UNITED STATES PATENT AND TRADEMARK OFFICE

APPLICATION NO.	FILING DATE	FIRST NAMED INVENTOR	ATTORNEY DOCKET NO.	CONFIRMATION NO.
10/672,667	09/26/2003	John Jiin Chung Yang	CIP2176A-CTI	9791
7590 09/22/2004 Raymond Y. Chan Suite 128 108 N. Ynez Ave. Monterey Park, CA 91754			EXAMINER PRICE, CARL D	
			ART UNIT 3749	PAPER NUMBER

Office Action Summary	Application No. 10/672,667	Applicant(s) YANG, JOHN JIIN CHUNG 	
	Examiner CARL D. PRICE	Art Unit 3749

DETAILED ACTION

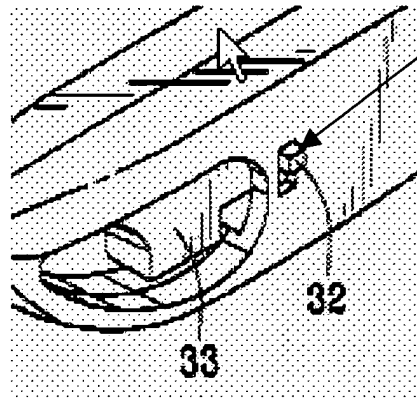
US006468070 (JON) (Figures 6 and 7) shows and discloses a casing having:

- a lighter housing, which has an internal cavity and a pusher cavity therein,
- a tubular lighter rod (16) extended from the lighter housing,
- the lighter housing has a safety slot (at 32) provided on a sidewall of the lighter housing to communicate the internal cavity with an exterior of the lighter housing,
- a fuel storage housing (30) disposed in the internal cavity of the lighter housing for storing liquefied gaseous fuel;
- an ignition system which comprises
 - o a gas emitting nozzle (31) communicated with the fuel storage housing for releasing gaseous fuel;
 - o a gas tube extended from the gas emitting nozzle to a top end portion of the lighter rod to form an ignition tip therein,

- a piezoelectric unit (40) supported in the internal cavity for generating piezoelectricity, wherein the piezoelectric unit comprises a movable pad and a spark generating tip extended to the ignition tip through the lighter rod for generating sparks when the movable pad of the piezoelectric unit is depressed; and

- a pusher button (33) which is supported in the pusher cavity in a slidably movable manner to drive the movable pad of the piezoelectric unit to be depressed;

- a gas releasing unit for control a flow of the liquefied fuel, wherein the gas releasing unit comprises a gas lever (not referenced in Figure 7; see (70,50,90) in Figure 2) having a pivot end engaged with the gas emitting nozzle and an actuating end arranged to be depressed so as to pivotally lift up the gas emitting nozzle for releasing the liquefied fuel, and a gas actuating arm integrally extended from the pusher button towards the actuating end of the gas lever such that when the pusher button is depressed, the gas actuating arm is driven to depress the actuating end of the gas lever for releasing the liquefied fuel so as to ignite the liquefied fuel at the ignition tip; and

- a safety arrangement, which comprises:
 - o a stop post integrally extended from the pusher button at a position parallel to the gas actuating arm;
 - o a locking member, which comprises a switching member slidably mounted on the sidewall of the casing along the safety slot and a stopper which is

integrally extended from the switching member into the lighter housing through the safety slot and is normally blocked up the pusher button sliding towards the piezoelectric unit,

FIG. 7
PRIOR ART

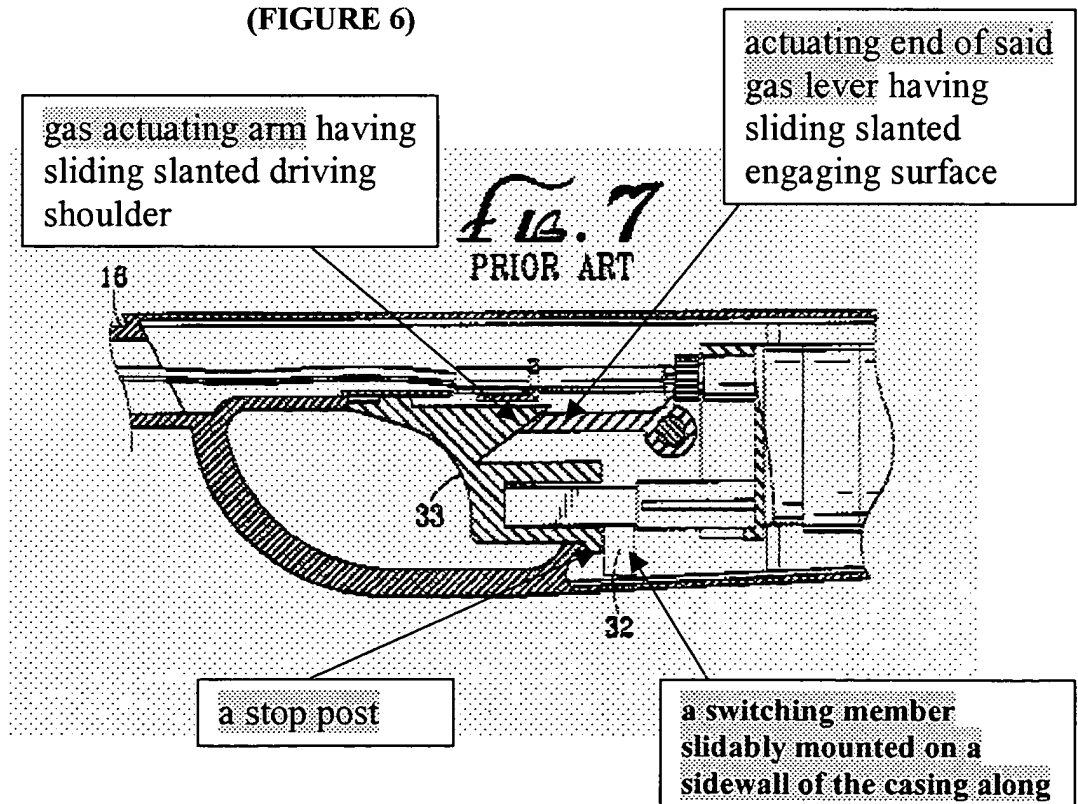
a switching member slidably mounted on a sidewall of the casing along a safety slot

gas actuating arm having sliding slanted driving shoulder

actuating end of said gas lever having sliding slanted engaging surface

a stop post

a switching member slidably mounted on a sidewall of the casing along

- wherein the safety slot is transversely provided on the sidewall of the lighter housing with respect to a sliding movement of the pusher button, wherein the switching member is slid on the sidewall of the lighter housing along the safety slot to drive the stopper between a locked position and an unlocked position, wherein at the locked position, the stop post is aligned with the stopper such that the pusher button is blocked to be pushed towards the piezoelectric unit for ignition, and at the unlocked position, the switch member is slid on the sidewall of the light housing along the safety slot to drive the stopper to move to an offset position that allows the pusher button to be depressed to depress the movable part of the piezoelectric unit and to depress the actuating end of the gas lever simultaneously for igniting the utility lighter,

- and a resilient element supported in the internal cavity of the lighter housing for urging a pushing force to the locking member to normally retain the locking member at the locked position.

US006468070 (JON)(FIGURES 5 AND 6) discloses the invention substantially as set forth in the claims with possible exception to a resilient element supported in the internal cavity of the lighter housing for urging a pushing force to the locking member to normally retain the locking member at the locked position.
